B I D A D D E N D U M 0 4

The items set forth herein, whether of omission, addition, substitution, or clarification are to be included in and form a part of the construction documents for the project listed above.

ORANGE-ULSTER BOCES
AXELROD - MAIN
BUILDING
ADDITIONS +
ALTERATIONS
53 GIBSON ROAD
GOSHEN, NY 10924

1 TOILET 517-519 DOMESTIC WATER RISER DIAGRAM
NOT TO SCALE

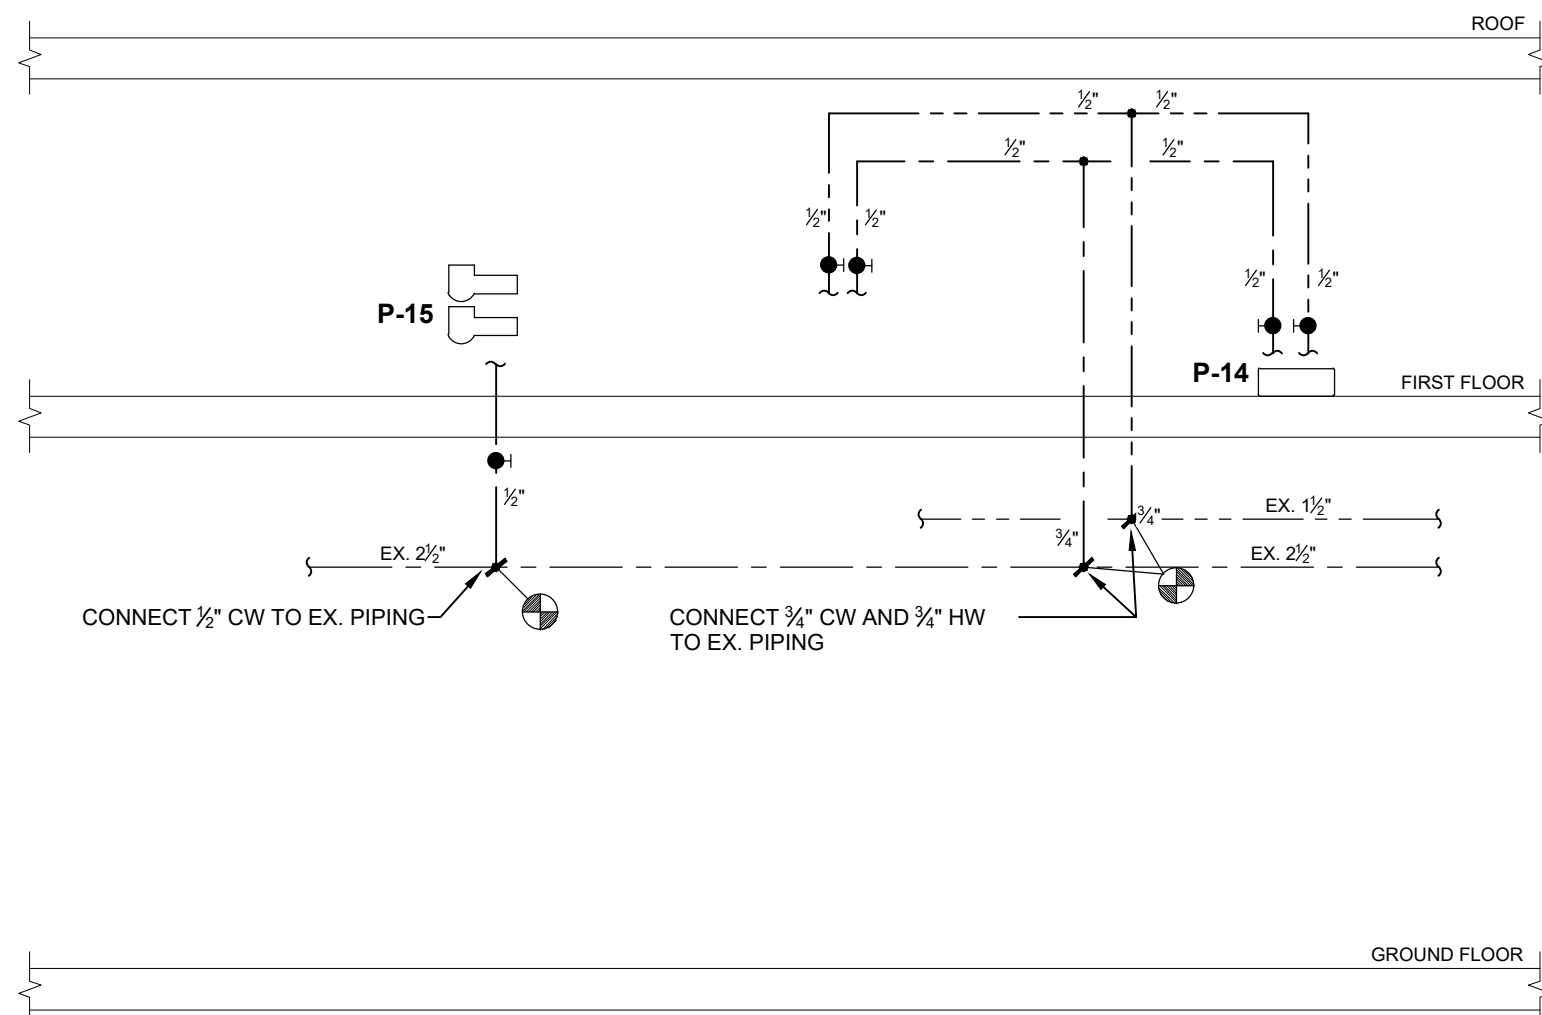
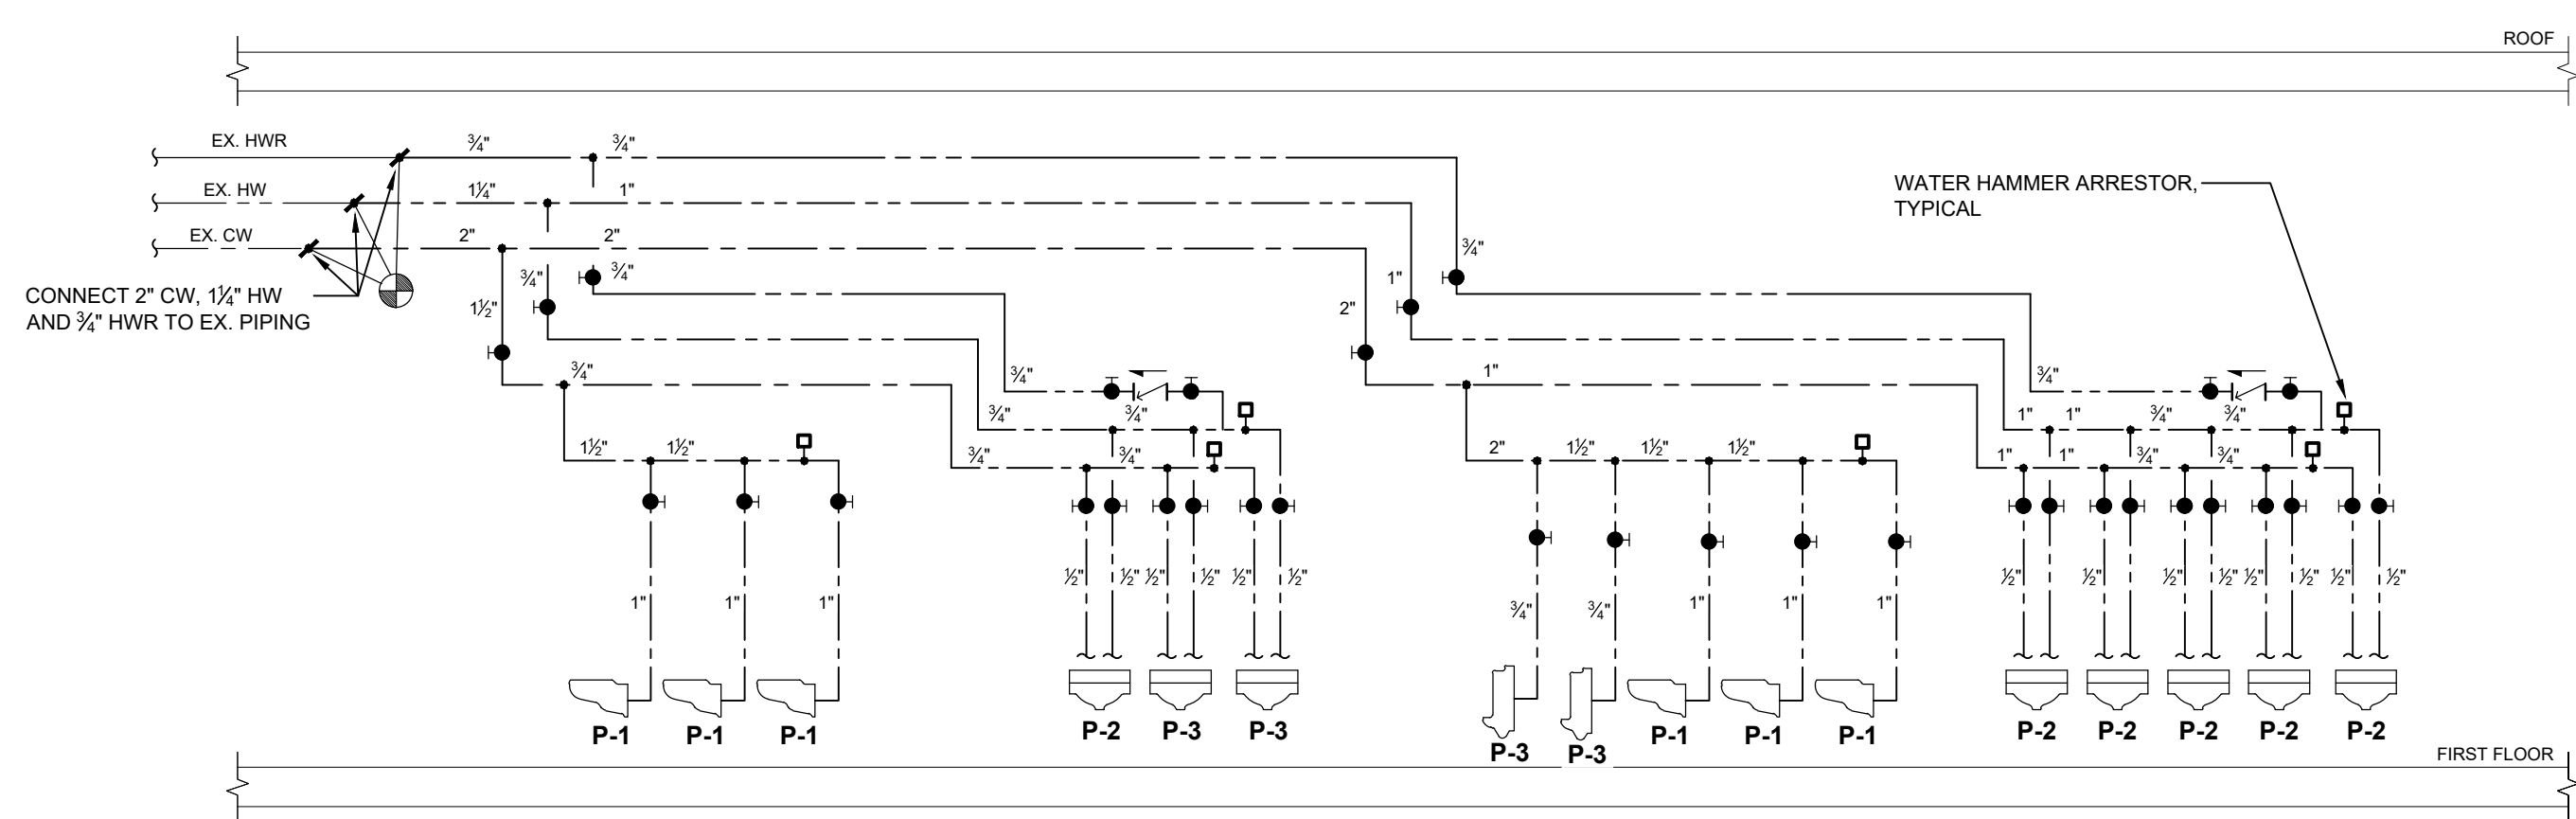
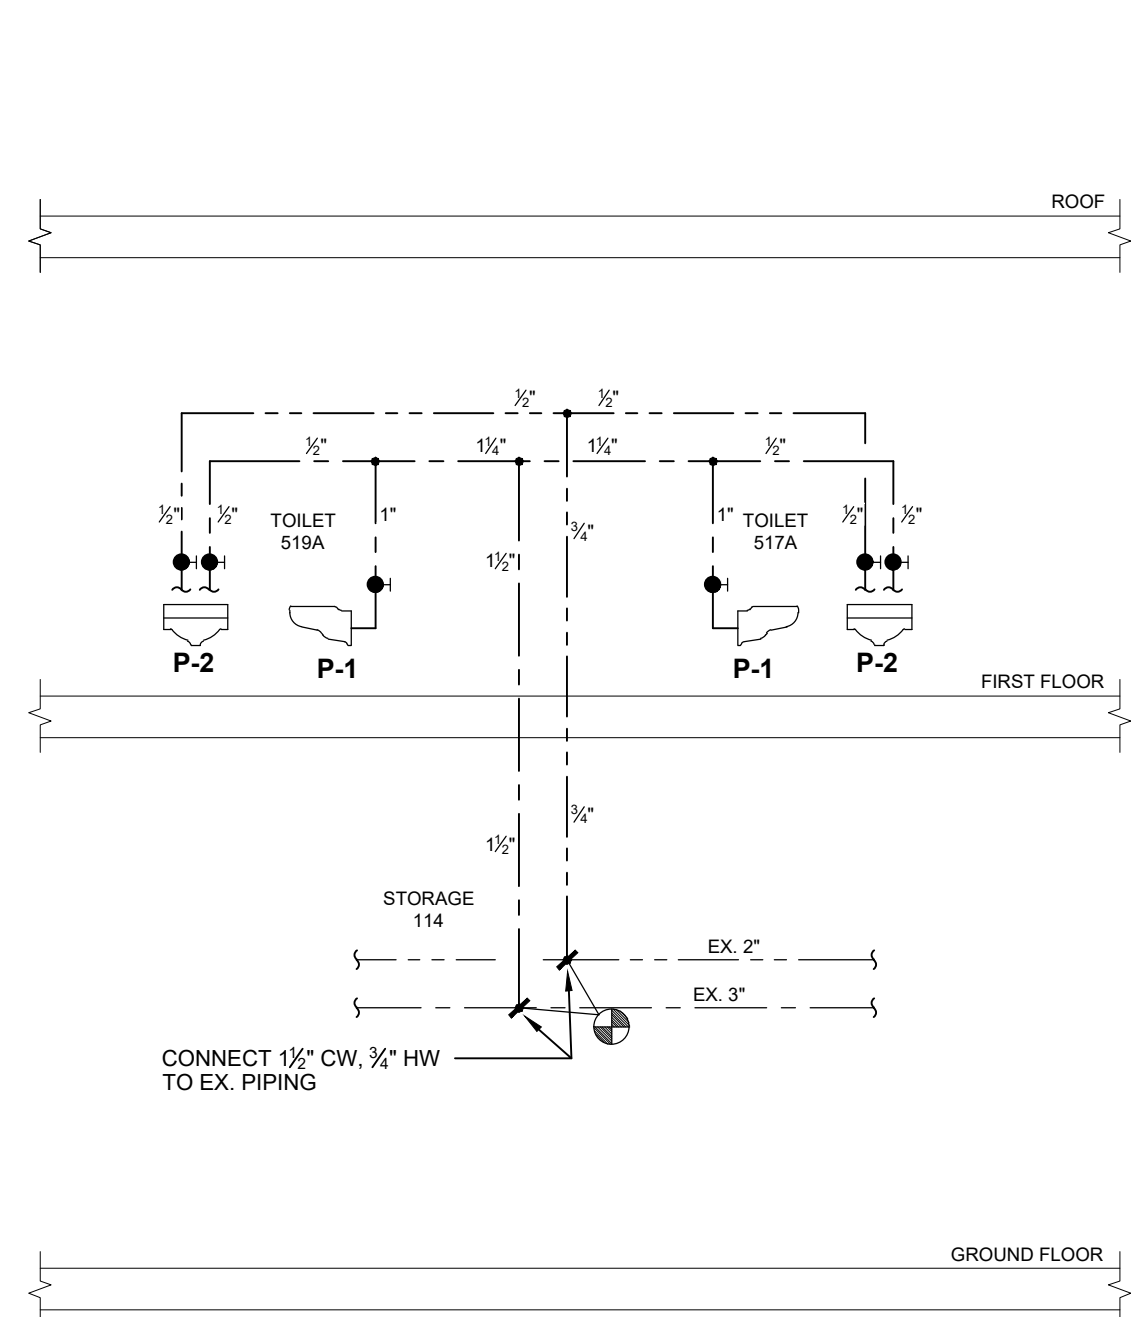
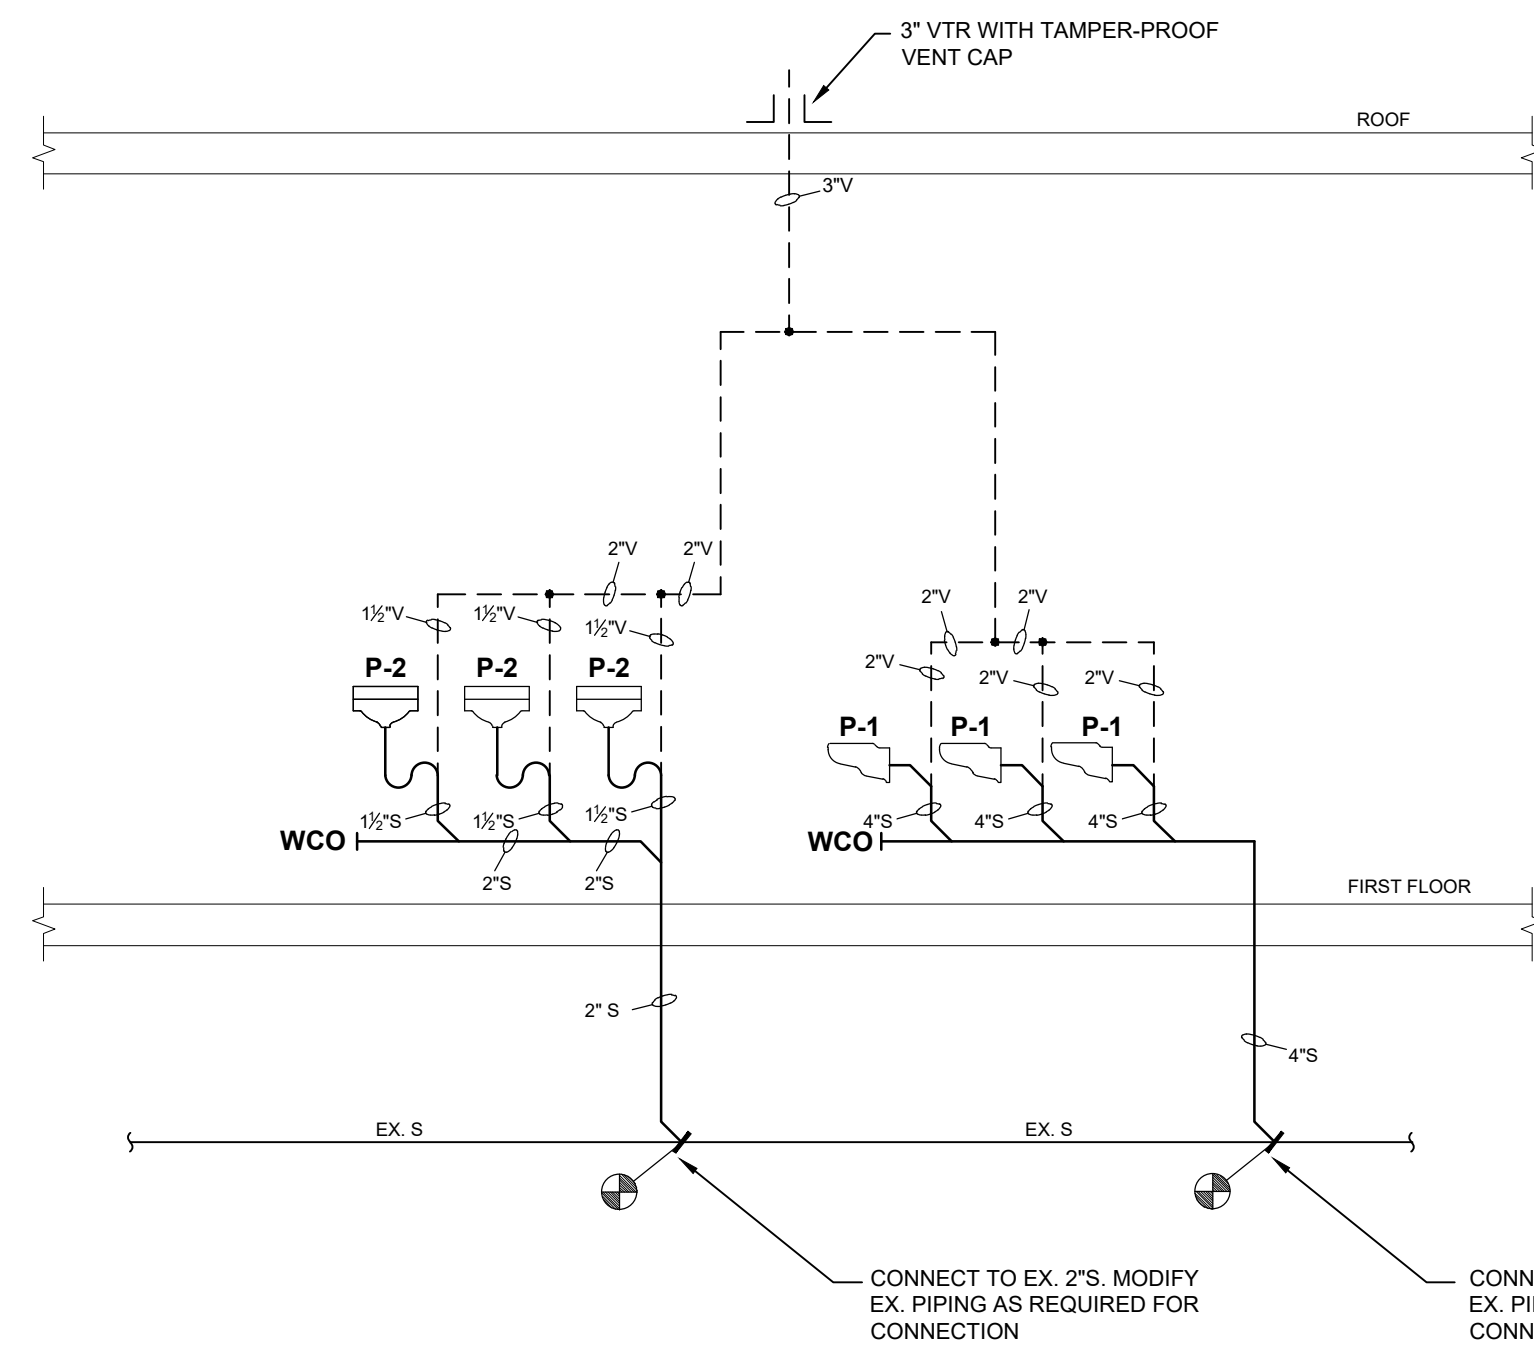
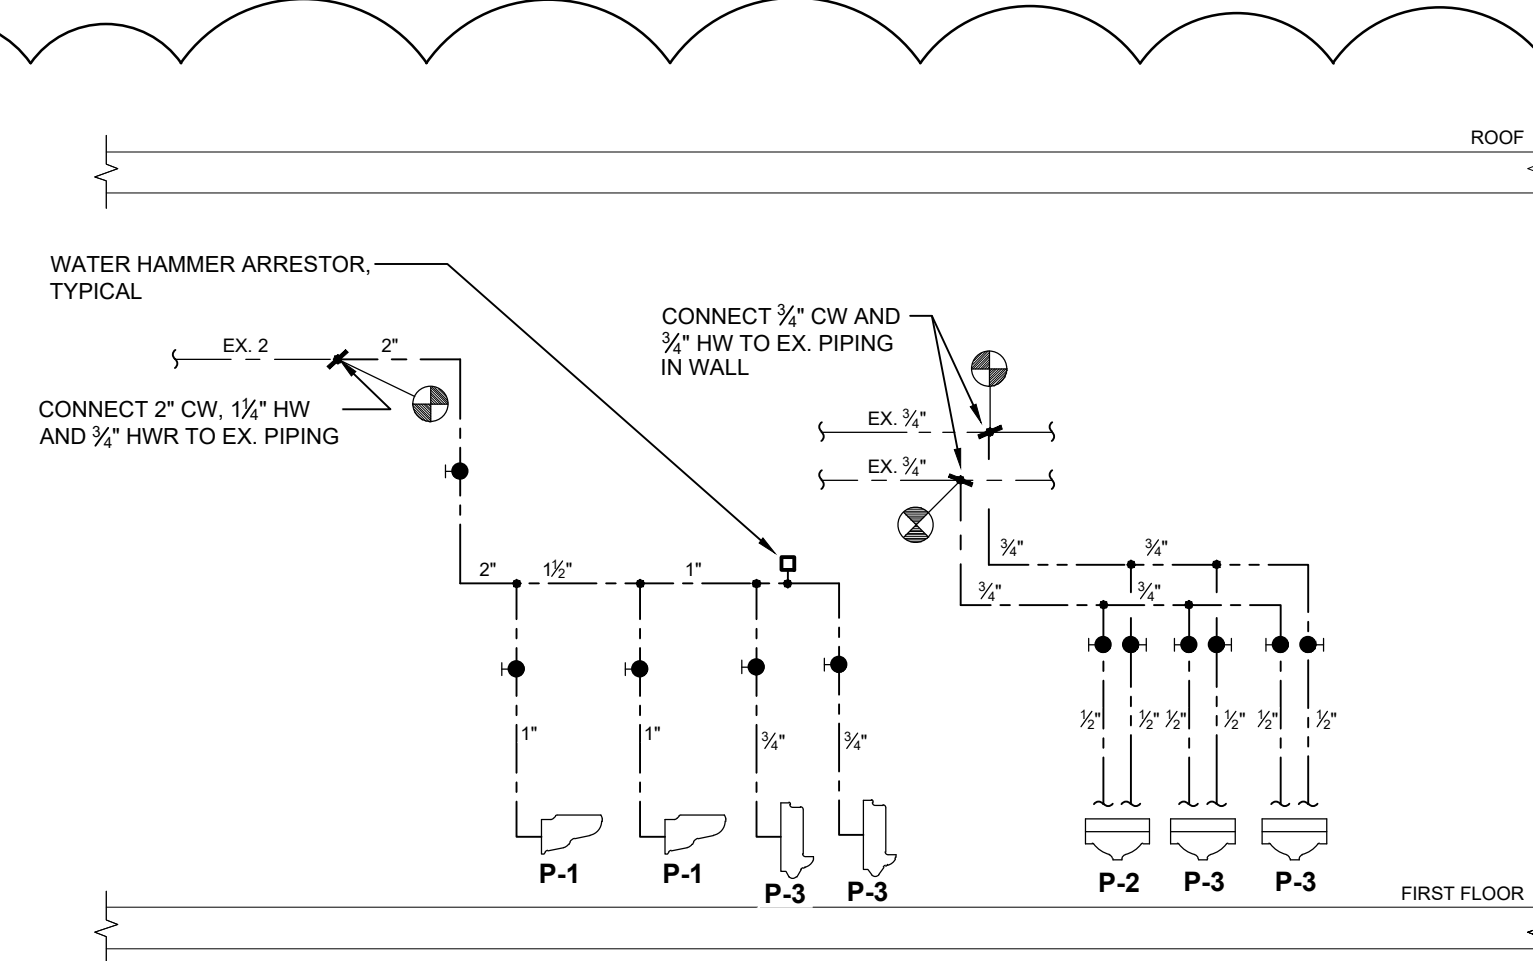
Drawing P201D – Plumbing First Floor Plan Part D
- 6.2 Attached please find attached new Plumbing Drawing P602 – Plumbing Details with riser diagram information.
